M1 Princes Motorway, Mount Ousley Interchange

REF submissions report

Roads and Maritime Services | April 2018

Figure 3.2 | Modified Design (Eastern roundabout and Mount Ousley Road)

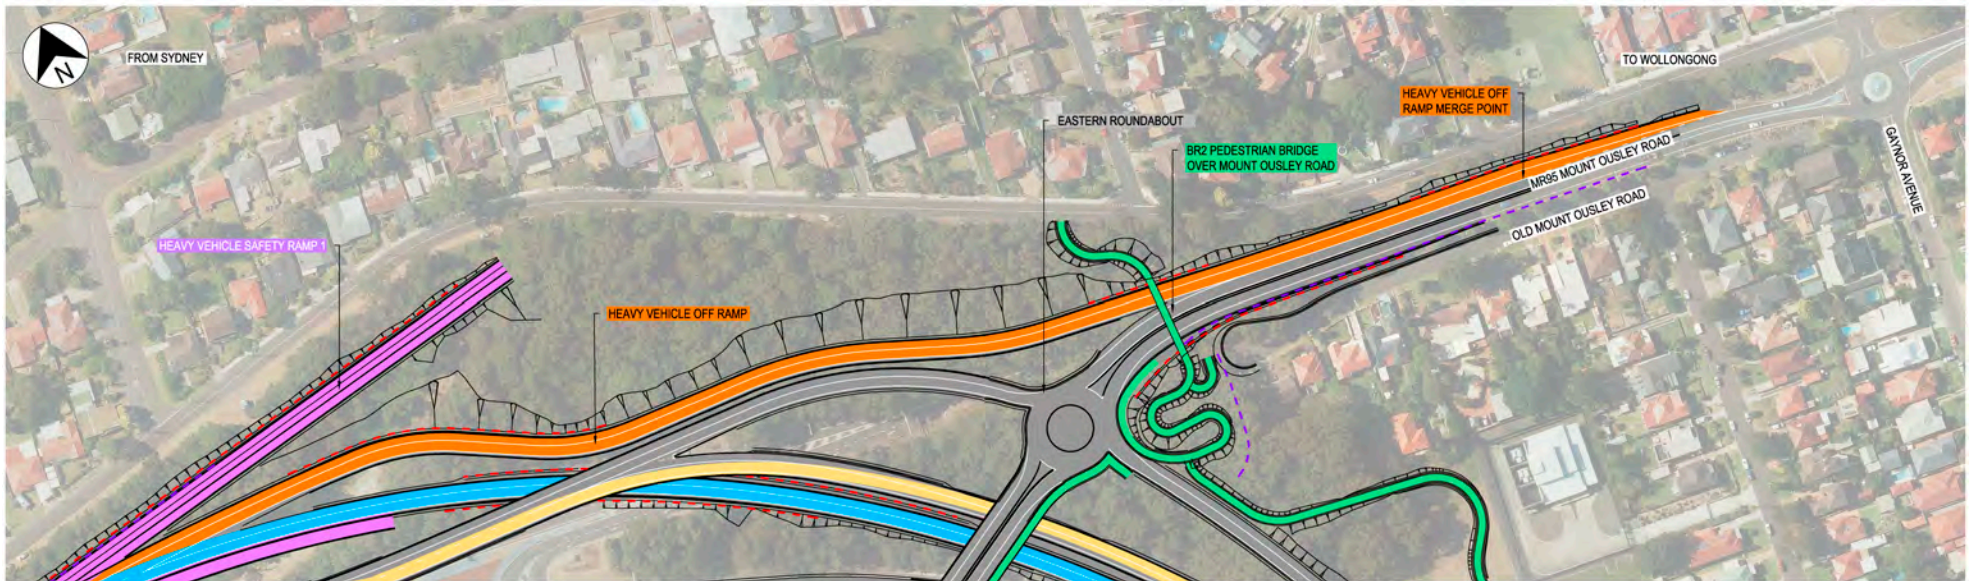
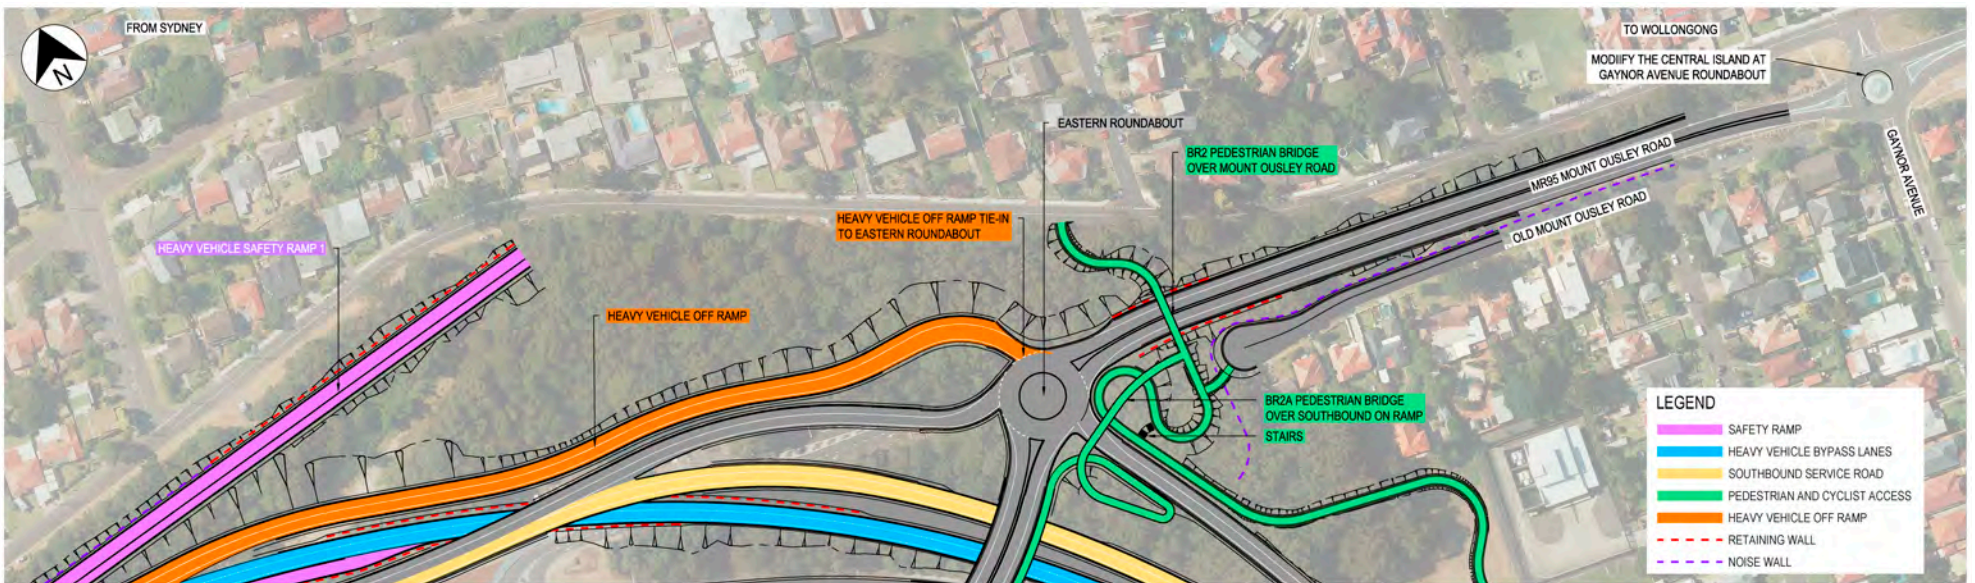
- Minor modifications to the Gaynor Avenue roundabout to address current safety concerns with the eastbound approach speed.
- Shortening the heavy vehicle on-ramp (onto Mount Ousley Road) by connecting it to the eastern roundabout, creating a fifth leg at the roundabout.
- Extending the pedestrian/cycle bridge over Mount Ousley Road across the southbound on-ramp, at the eastern roundabout.

The proposed design change involves reducing the length of the heavy vehicle off ramp so that it would no longer merge into Mount Ousley Road before the Gaynor Avenue roundabout. Instead, the bypass would be connected to the eastern roundabout, meaning that heavy vehicles would re-join the main traffic flows at the roundabout instead of merging on approach to Gaynor Avenue.

The pedestrian bridge over Mount Ousley Road is proposed to be extended across the southbound service road, to reconnect with the shared path on the Mount Ousley Road Bridge over the M1 Princes Motorway. The design change would involve some reconfiguration of the shared path to achieve suitable gradients for pedestrians and cyclists travelling south towards the TAFE campus as shown in Figures 3.1 and 3.2.

The design change involves some minor increases to the footprint of the eastern roundabout to accommodate a fifth leg, with suitable pavement geometry to accommodate movement through the roundabout by all heavy vehicles.

Road and would not result in any change to the assessment of impacts on those properties in terms of noise, air quality or visual impact. Traffic queues and delays have been assessed in Section 4.1.2 and are acceptable. The proposed design change is shown in Figures 3.1 and 3.2.
